1 Addendum 1		03/28/2017
Revisions:		Date

Drawing Title	
SECOND FLOOR PLAN	
Approved: Project Director Approver

Project Title	
VA HEALTH CARE SYSTEM	
Location VAS 438-16-104 BLDG. 5 CHAPEL SIOUX FALLS, SD 57105	
Date	2017.03.13
Checked	RLK
Drawn	Author

SEAL	ARCHITECT:
	Chiodini ARCHITECTS Architecture / Interior Design / Graphics 1401 S. Brentwood Blvd. / Suite 575 / St. Louis, Missouri 63144 314-725-5588 / arch@chiodini.com

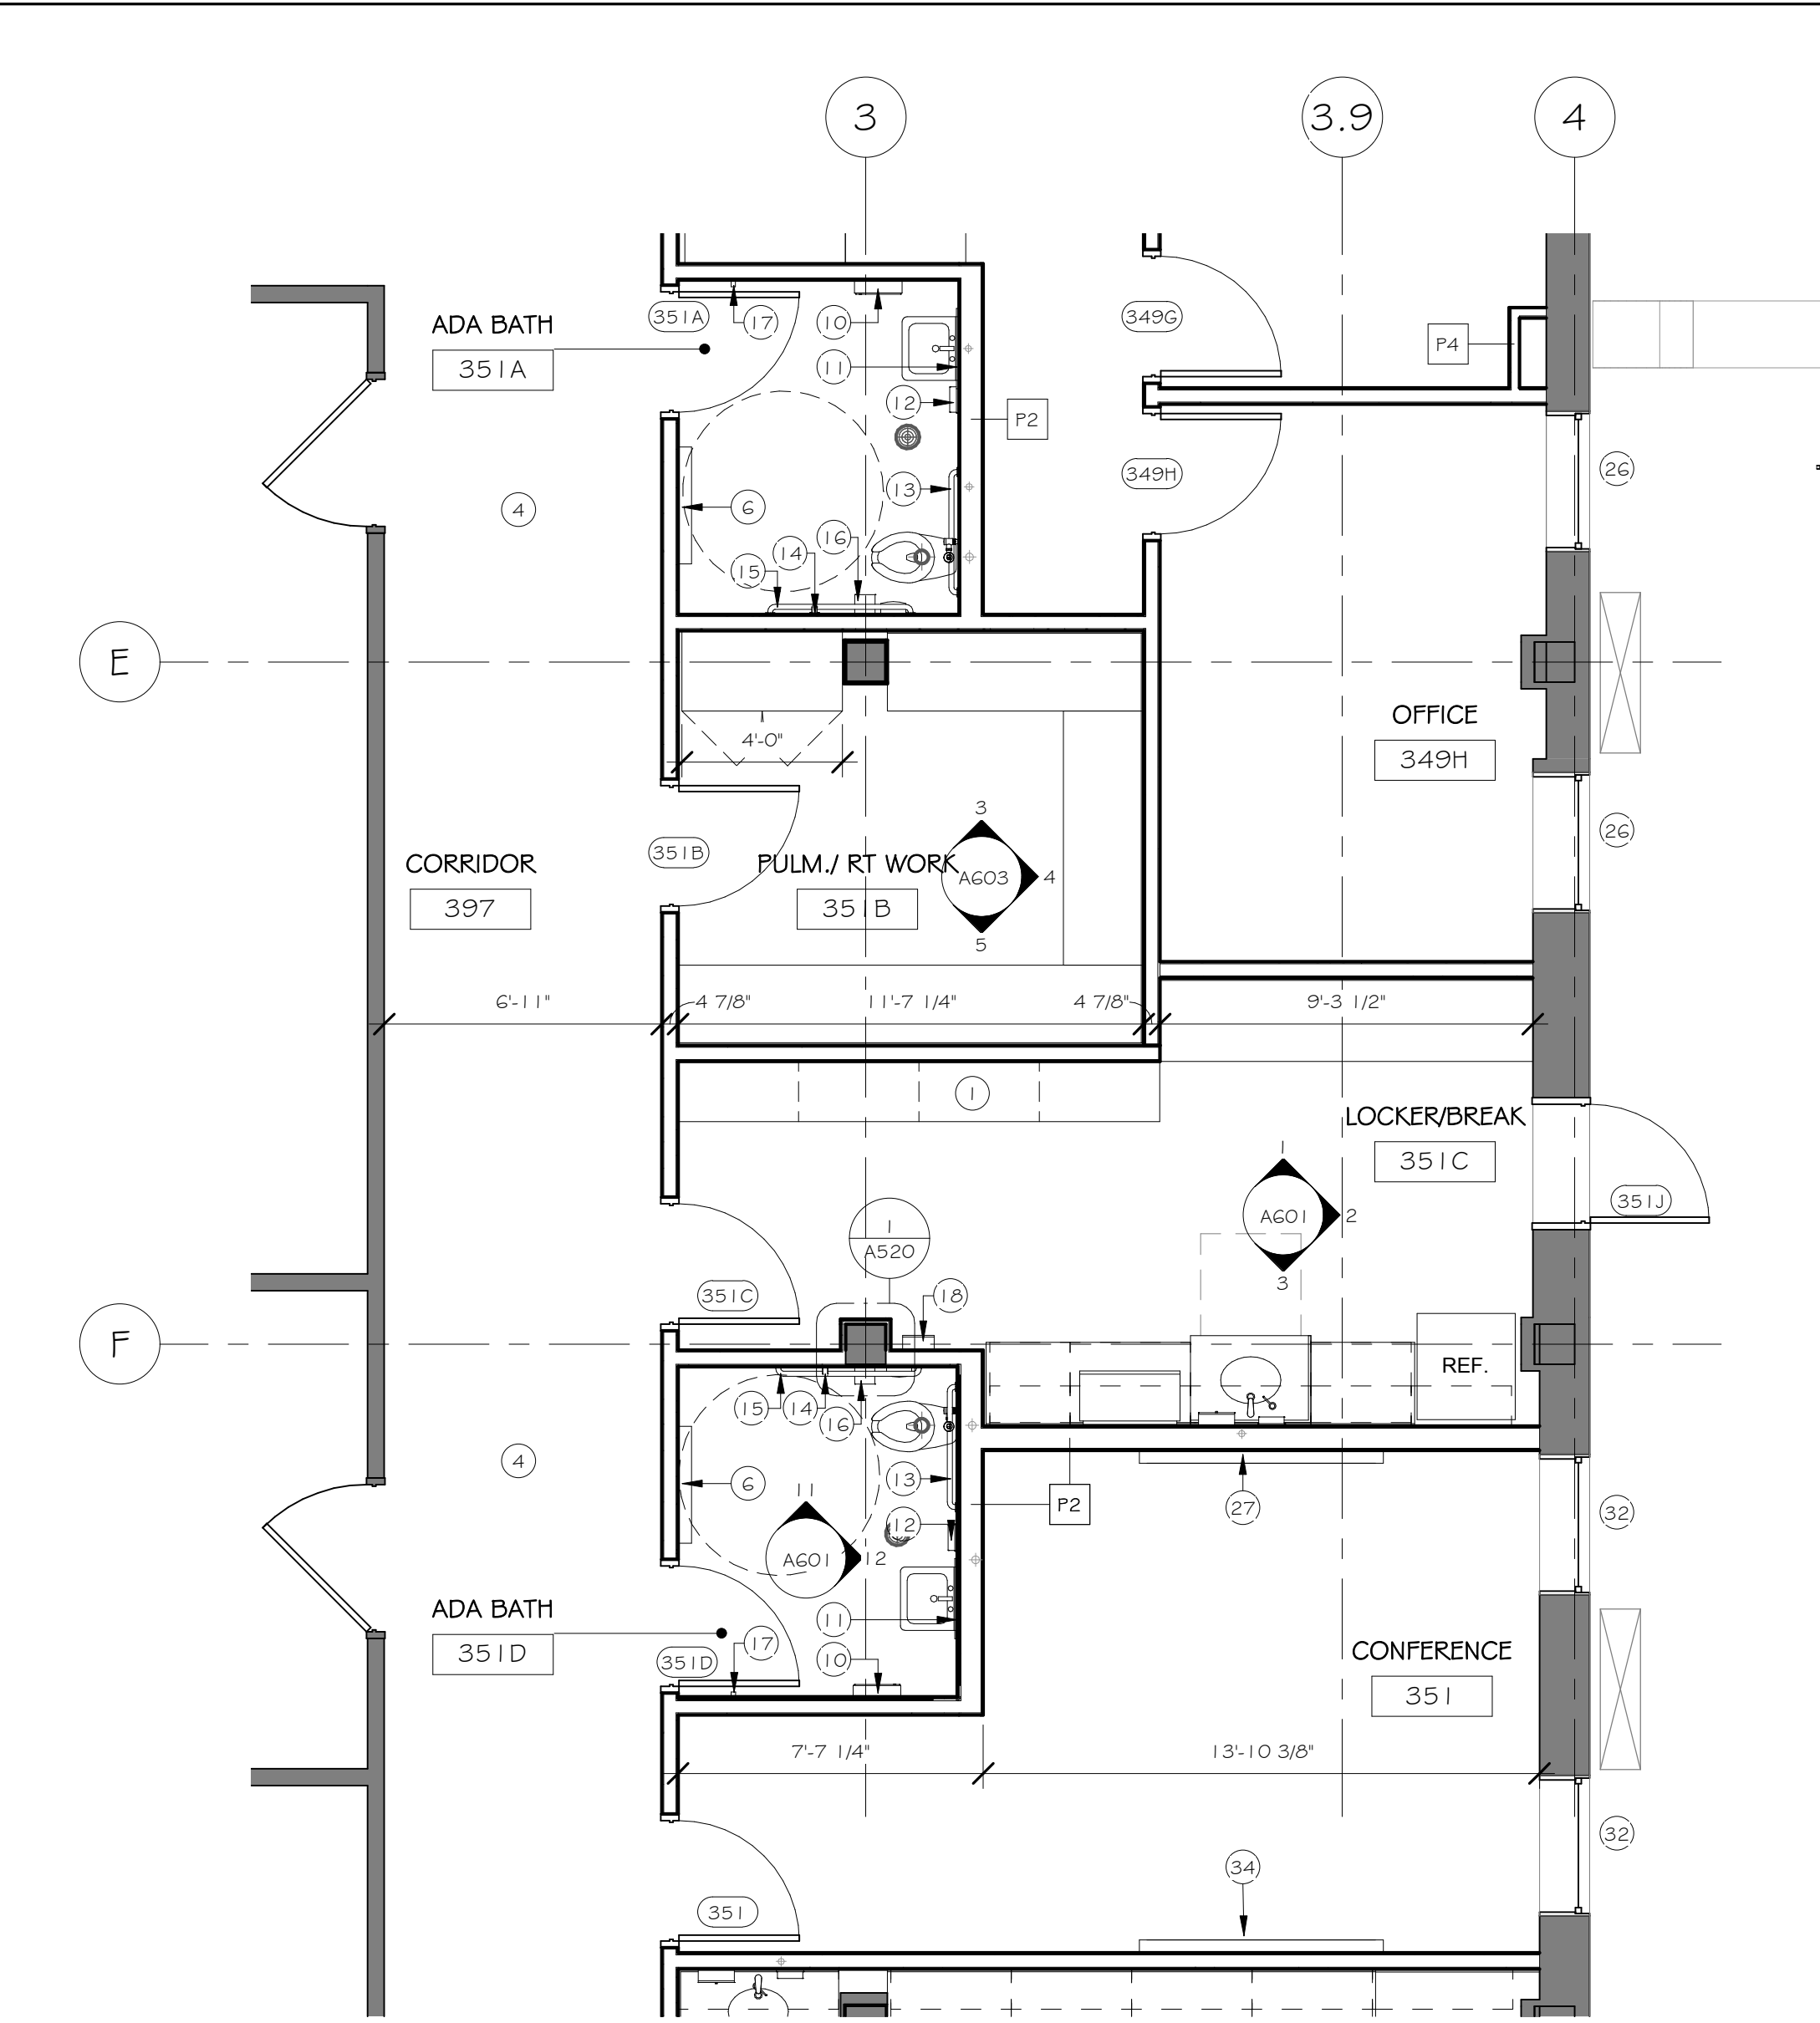
1 NEW 2 HR FIRE WALL SHAFT ASSEMBLY FROM FLOOR TO UNDERSIDE OF DECK, TO BE PAINTED TO MATCH ADJACENT WALL. CONTRACTOR TO FIRE CAULK ALL PENETRATIONS GOING THROUGH 3RD FLOOR SLAB AND CAULK ALL PENETRATIONS COMING THROUGH SHAFT WALL.

2 NEW DUCT PENETRATION THROUGH WALL. G.C. TO CAULK & PAINT WALL TO MATCH ADJACENT WALL ASSEMBLY (RE: MEP FOR SIZE OF OPENING).

3 CONTRACTOR TO REBUILD TOP OF SHAFT TIGHT TO ALL PENETRATING UTILITIES. CONTRACTOR TO FIRE CAULK ALL PENETRATIONS GOING THROUGH 3RD FLOOR SLAB AND CAULK ALL PENETRATIONS COMING THROUGH SHAFT WALL.

4 RELOCATE EMS/JOHNSON CONTROL PANEL FROM 3RD FLOOR TO 2ND FLOOR.

NOTE TO CONTRACTOR:

CONTRACTOR TO KEEP FIRE RATINGS IN TACT AT ALL TIMES DURING CONSTRUCTION BY PROVIDING ONE OF THE FOLLOWING SAFETY OPTIONS:

ONE - LEAVE THE EXISTING SPRINKLER SYSTEM OPERATIONAL IN THE RENOVATED AREA AND PROVIDE UPRIGHT SPRINKLER HEADS ON THE EXISTING PIPE TO PROVIDE COVERAGE IN THE AREA OF WORK PER NFPA 13 DURING CONSTRUCTION. THIS WILL LIKELY INVOLVE MOVING SPRINKLERS TO WITHIN 12 INCHES OF THE DECK ABOVE. AFTER THE NEW SPRINKLER PIPING IS INSTALLED TESTED AND APPROVED, THE SPRINKLERS AT THE DECK LEVEL AND THE EXISTING PIPING SHALL BE REMOVED.

TWO - CONTRACTOR MAY SHUTDOWN THE EXISTING SPRINKLER SYSTEM IN THE AREA OF WORK PROVIDED THAT THE CONTRACTOR INSTALL A 1-HOUR FIRE-RESISTANCE RATED SEPARATION BETWEEN EVERY OCCUPIED SPACE ADJACENT TO THE CONSTRUCTION AREA. CONTRACTOR SHALL COORDINATE WITH THE VETERANS ADMINISTRATION, THE CONTRACTING OFFICER, AND THE AEC ALL FIRE-RESISTANCE RATED SEPARATIONS SHALL COMPLY WITH NFPA 101 AND UL LISTINGS.

THE SPRINKLER MAIN LOCATED IN THE CORRIDOR IS REQUIRED TO REMAIN ACTIVE DURING BUSINESS HOURS FOR THE DURATION OF THE CONSTRUCTION PERIOD IN ORDER TO SUPPLY THE SPRINKLERS IN THE RESPIRATORY CARE PORTION OF THE FLOOR (NOTED AS OUT OF CONTRACT ON THE PLAN). THE CONTRACTOR IS PERMITTED TO TAKE THE SPRINKLER MAIN TEMPORARILY OUT OF SERVICE AFTER HOURS TO ALLOW THE REMOVAL OF THE DEMOLISHED SPRINKLER BRANCH PIPING AND FOR RE-CONNECTION OF THE NEW SPRINKLER BRANCH PIPING. CONTRACTOR SHALL PROVIDE A FIRE WATCH DURING THE TIME THE SPRINKLER SYSTEM IS TAKEN OUT OF SERVICE. THE TIMING AND DURATION OF THE SPRINKLER SYSTEM SHUTDOWN SHALL BE COORDINATED WITH AND APPROVED BY THE VA AND AUTHORITY HAVING JURISDICTION.
